Access Compliance Report

Public Rights-of-Way

(Curb Ramps)

Intersection ID: 3596	Main Street: DARBYSHIRE_PL	Cross Street: TREYBURN_DR	Location: W
ADA ID: 8E2EB8FA9DA4	Ramp Type: Perpendicular	Initial Pass/Fail: Fail	Overall Compliance: No
Codes/Mitigation Info/Possible Solution			Severity Score: 12.5
			Field Measurements/Component Compliance

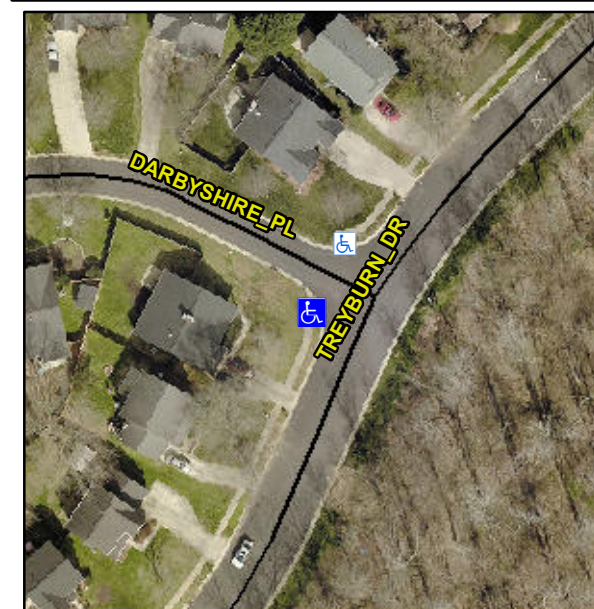
Not Found, R304.2.2

Compliance	Description	Data	Compliance	Description	Data
N/A	Ramp Length (in)	47.0	No	Ramp Slope (%)	8.5
Yes	Ramp Width (in)	48.0	Yes	Ramp XSlope (%)	1.8
N/A	Flare Type LT	N/A	N/A	Flare Type RT	N/A
N/A	Flare Slope LT (%)	N/A	N/A	Flare Slope RT (%)	N/A
N/A	Flare Traversable LT?	N/A	N/A	Flare Traversable RT?	N/A
N/A	Landing Length (in)	N/A	N/A	DWS Provided?	N/A
N/A	Landing Width (in)	N/A	N/A	DWS Contrast?	N/A
N/A	Landing Slope (%)	N/A	N/A	DWS Length (in)	N/A
N/A	Landing X Slope (%)	N/A	N/A	DWS Full Width?	N/A
N/A	Landing Curb? (Y/N)	N/A	N/A	DWS Offset (in)	N/A
N/A	Shared Landing?	N/A			
N/A	Gutter Ponding?	N/A	N/A	Gutter Slope (%)	N/A
N/A	Gutter Lip Ht (in)	N/A	N/A	Gutter X Slope (%)	N/A
N/A	Painted X Walk1?	No	N/A	Painted X Walk2?	N/A
	X Walk 1 Direction	To NE		X Walk 2 Direction	N/A
N/A	X Walk 1 Width (in)	N/A	N/A	X Walk 2 Width (in)	N/A
	X Walk 1 Slope (%)	0.6		X Walk 2 Slope (%)	N/A
	X Walk 1 X Slope (%)	1.3		X Walk 2 X Slope (%)	N/A

Possible Solutions:

Remove & Replace Entire Ramp.
